Product Change Notification

Date Issued :	November 12, 2026	**PCN Number :**	519070
Reason for Change :	Obsolete		
PCN Subcategory:	OBS-Obsolescence with Replacement		
Description of Change :	This notification is to inform you about the obsolescence of parts referenced in this notice. Please review the below for details and connect with your Molex Sales Engineer for additional queries.		
Reason for Short Notice :	Supplier Constraints		
Planned Implementation Date :	May 14, 2027		
Recommended replacement parts :	Please see the attached replacement parts list .xls file.		
Last Time Buy Date for Obsolete Parts :	December 31, 2026		
Last Time Ship Date for Obsolete Parts :	March 31, 2027

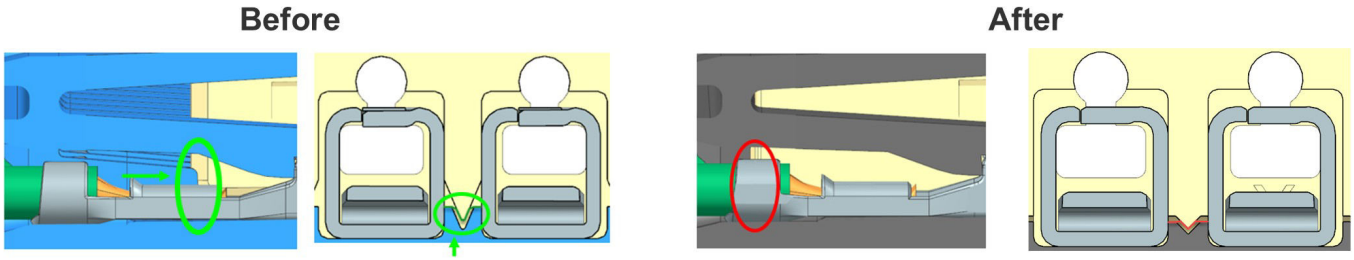
1. Commonizing internal geometry design with standard MX150 connectors

2. Housing & TPA resin grade from Class II → Class I to meet creepage & clearance requirements

3. TPA color from Natural → Black
